Access Compliance Report

Public Rights-of-Way

(Curb Ramps)

Intersection ID: 18436	Main Street: E_INDEPENDENCE_BV	Cross Street: SHARON_FOREST_DR	Location: SE
ADA ID: 64E8CD1BE4ED	Ramp Type: PerpDiag	Initial Pass/Fail: Fail	Overall Compliance: No
Severity Score: 22.5			
Codes/Mitigation Info/Possible Solution		Field Measurements/Component Compliance

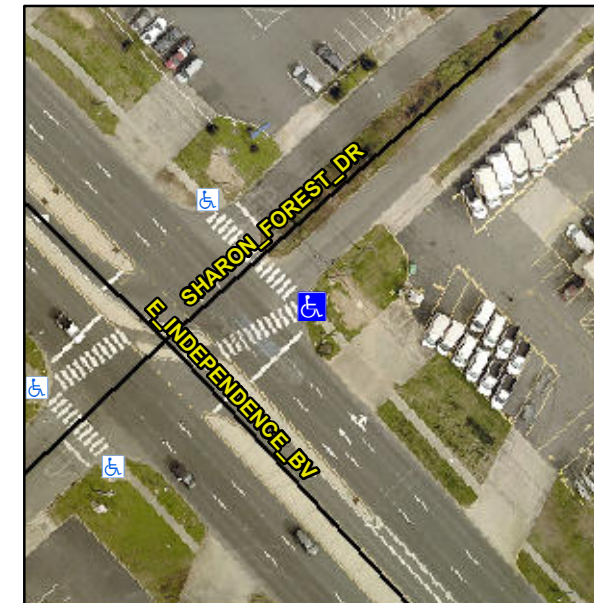
Not Found, R304.5.1, R304.2.2, R304.5.3

Compliance	Description	Data	Compliance	Description	Data
N/A	Ramp Length (in)	60.0	No	Ramp Slope (%)	9.3
No	Ramp Width (in)	41.0	No	Ramp XSlope (%)	3.8
N/A	Flare Type LT	N/A	N/A	Flare Type RT	N/A
N/A	Flare Slope LT (%)	N/A	N/A	Flare Slope RT (%)	N/A
N/A	Flare Traversable LT?	N/A	N/A	Flare Traversable RT?	N/A
N/A	Landing Length (in)	N/A	N/A	DWS Provided?	N/A
N/A	Landing Width (in)	N/A	N/A	DWS Contrast?	N/A
N/A	Landing Slope (%)	N/A	N/A	DWS Length (in)	N/A
N/A	Landing X Slope (%)	N/A	N/A	DWS Full Width?	N/A
N/A	Landing Curb? (Y/N)	N/A	N/A	DWS Offset (in)	N/A
N/A	Shared Landing?	N/A			
N/A	Gutter Ponding?	N/A	N/A	Gutter Slope (%)	N/A
N/A	Gutter Lip Ht (in)	N/A	N/A	Gutter X Slope (%)	N/A
N/A	Painted X Walk1?	Yes	N/A	Painted X Walk2?	Yes
	X Walk 1 Direction	To NW		X Walk 2 Direction	To SW
N/A	X Walk 1 Width (in)	117.0	N/A	X Walk 2 Width (in)	120.0
	X Walk 1 Slope (%)	6.2		X Walk 2 Slope (%)	4.5
	X Walk 1 X Slope (%)	0.0		X Walk 2 X Slope (%)	6.1

N/A	Ramp inside XWalk1?	Yes	N/A	Ramp inside XWalk2?	Yes
	Road Slope (%)	0.1	N/A	Clear Space?	N/A
	Road X Slope (%)	5.5	N/A	Clear Space to XWalk (in)	N/A
N/A	Any Obstructions?	N/A	N/A	Storm Grate/Utility Hazard?	N/A
	Obstruction Type			Storm Grate/Utility Type	
		N/A			N/A
		Yes		Surface Condition? (G/P)	Good

Remove & Replace Curb Ramp With Two New Directional Ramps or Equivalent.
